January 31, 2001

Attn: Mr. Wesley P. Moody  
Director, Geotechnical Engineering Bureau

**Summary Geotechnical Report: Post-construction  
SR 443 (Delaware Avenue) Landslide at Normans Kill  
Elsmere (Bethlehem), NY**

FIG. 1

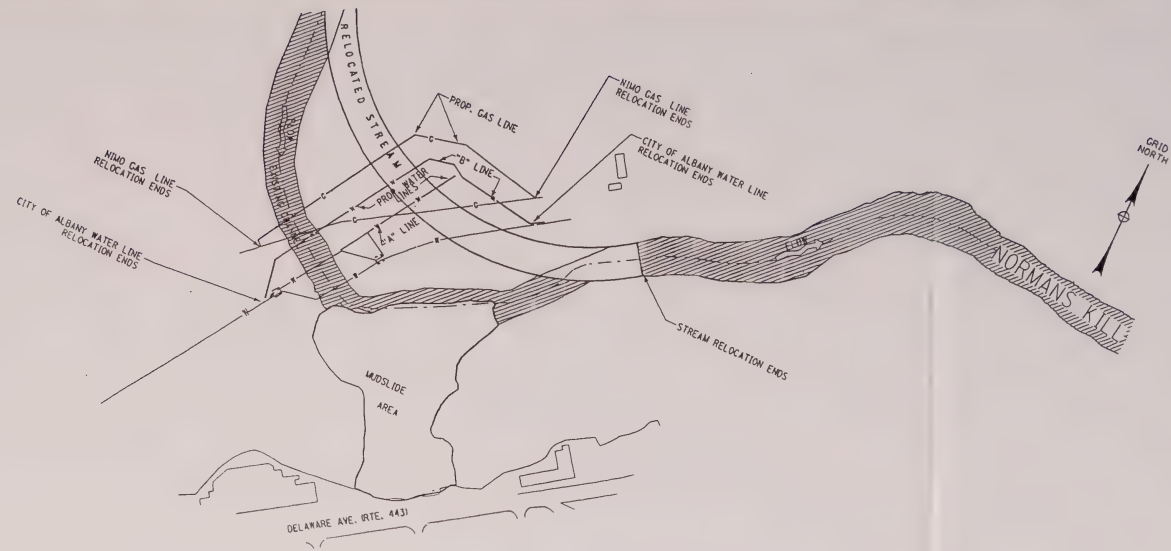
The inclinometers in the slide mass have not shown movement since the slide area was re-graded. Refer to Photos 1 and 6 for locations of instrumentation groups. The inclinometers showed movements early during emergency construction. Refer to Figure 1 for a plot of inclinometer-measured ground displacement (SI 142 J, near the slide toe). This plot shows that the slide moved as viscous fluid from the ground surface down to a depth of approximately 25 feet, with an additional small increment of movement near the bottom of the inclinometer casing (depth range of 41 to 49 feet). The pavement above the headscarp does not show any signs of slide-movement cracks or scarp retrogression.

We recommend that the inclinometers be monitored at least every three months over the next year, and more often if ground movements are suspected. The groundwater conditions might become elevated following spring recharge and periods of sustained precipitation (significant rainfall over several days). The piezometers should be monitored monthly and whenever extreme wet periods occur (unusually high amounts of sustained precipitation or peak stream flows). Alternatively, data loggers could be attached for continuous readings.

PHOTO 1: PANORAMA OF SLIDE AREA LOOKING NORTH FROM DELAWARE AVENUE.

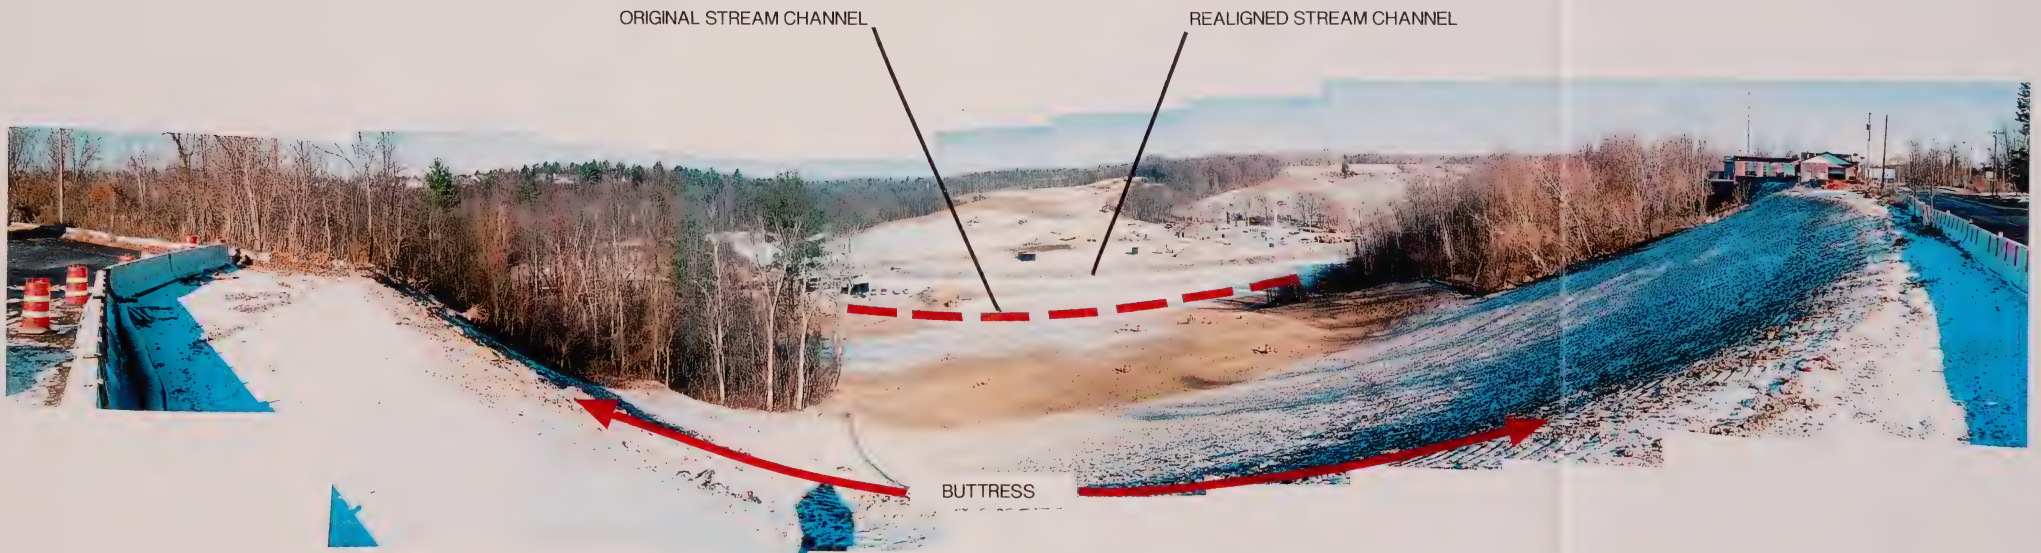
The evaluation of mitigation measures is based on the conditions observed during the December 9<sup>th</sup> reconnaissance. No stability analyses were performed. Photographs 1 through 18 (attached) show the observed conditions. Photo 1 shows a panoramic view of the landslide from Delaware Avenue looking north to the Normans Kill stream. The subsequent permanent earthwork has generally buried the initial emergency measures. The riprap along the realigned stream channel is now being covered with soil (for non-geotechnical reasons). The counterberm filling of the interim stream channel, in addition to the slide debris in the original stream, has added significantly more resistive weight to the slide toe. The slope of the counterberm surface is gentle to promote surface drainage (about 3% slope), and together with the riprap in the relocated stream channel should provide a stable stream bank. Photos 2, 3, and 4 show various views of the counterberm and realigned stream channel.

The final buttress was completed using light-weight pumice rock fill and is generally stable in appearance, except for local runoff erosion near the west end (refer to Photos 1 and 5). Diverting the surface runoff flow could mitigate the surface erosion by piping the collected water away from the steep slope. Alternatively, the erodable slope could be reinforced by installing a geosynthetic erosion control mat made specifically for runoff conditions.

PHOTO 6: CENTRAL AREA OF LANDSLIDE, LOOKING NORTH. NOTE THE 3 MIDDLE AND 3 UPPER ORANGE BARRELS, WHICH MARK THE LOCATIONS OF GEOTECHNICAL INSTRUMENTS. THE LOWER MOST INSTRUMENTS (#16) ARE LOCATED OVER THE BURIED ORIGINAL STREAM CHANNEL.

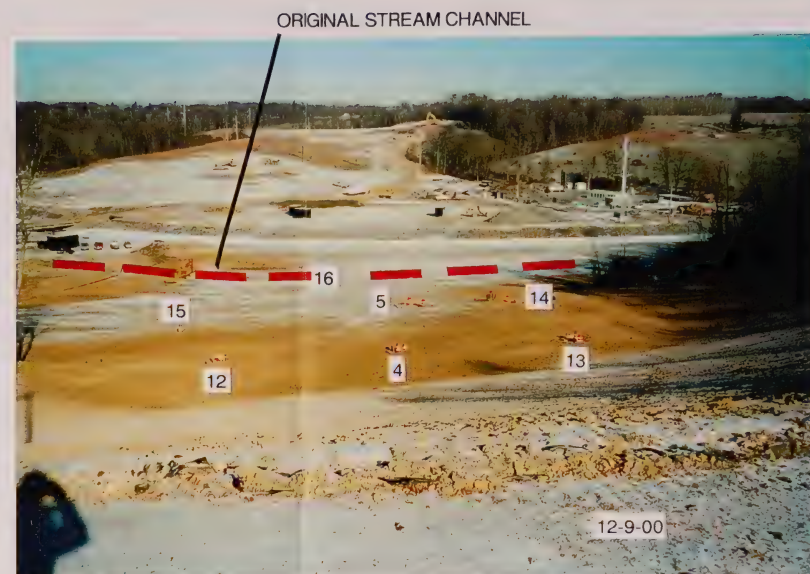
Piezometers at the boring B-15 location (west central slide area) are not functioning; however, the instruments at boring locations B-5, B-12, and B-14 (SI #'s 142 I, E & J) should provide sufficient information for this location of the landslide (refer to Photo 6 for instrument locations). The inclinometers at boring locations B-4, B-5, and B-16 are in the centerline of the landslide and appear to be stable and capable of further monitoring.
